# UNITED STATES PATENT AND TRADEMARK OFFICE

APPLICATION NO.	FILING DATE	FIRST NAMED INVENTOR	ATTORNEY DOCKET NO.	CONFIRMATION NO.
10/636,120	08/07/2003	Gerardo Orozco-Abundis	200206588-1	1561

## Office Action Summary

## DETAILED ACTION

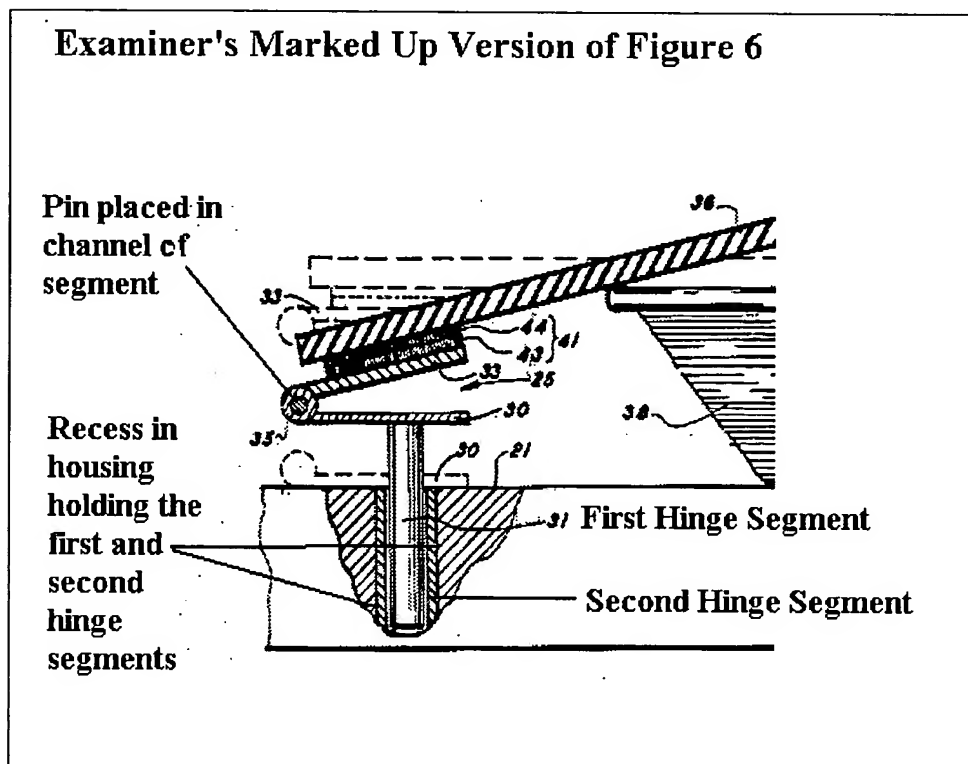
With respect to claim 3, Figure 6 shows at least one slot (recess) 32 in the housing 21, the at least one slot 32 operable to engage with at least a portion (First Hinge Segment) of said at least one telescopic hinge 35 to prevent inadvertent decoupling of said at least one telescopic hinge 35 from said housing 21. (See the Examiner's Marked-up Figure Below)

With respect to claim 4, Figure 6 of Wakeman illustrates the housing having at least one recess corresponding to the at least one telescopic hinge 35. (See Figure Below.)

With respect to claims 4 and 5, Figure 5 of Wakeman illustrates the housing having a plurality of recesses, with each telescopic hinge 35 being inserted into a corresponding recess 32 to couple said lid 36 with the housing 21. The recess is also illustrated in the Examiner's Marked-up version of Figure 6.

With respect to claims 6 and 8, the at least one telescopic hinge 35 of Lee et al., the Examiner's Marked-up version of Figure 6 shows a first and second hinge segments. Figure 6 shows at least one hinge segment disposed in the recess in the housing 21.

With respect to claims 13 and 14, Figure 6 of Wakeman teaches the first segment comprising a ledge 30 near an end of the first segment, the ledge surrounding an opening (recess) at the end. See the Examiner's Marked-up copy of Figure 6.

With respect to claim 18, the Examiner's Marked-up version of Figure 6 shows a segment, generally shown at 33, comprising a channel operable to accept a pin to pivotally couple the lid to the hinge.
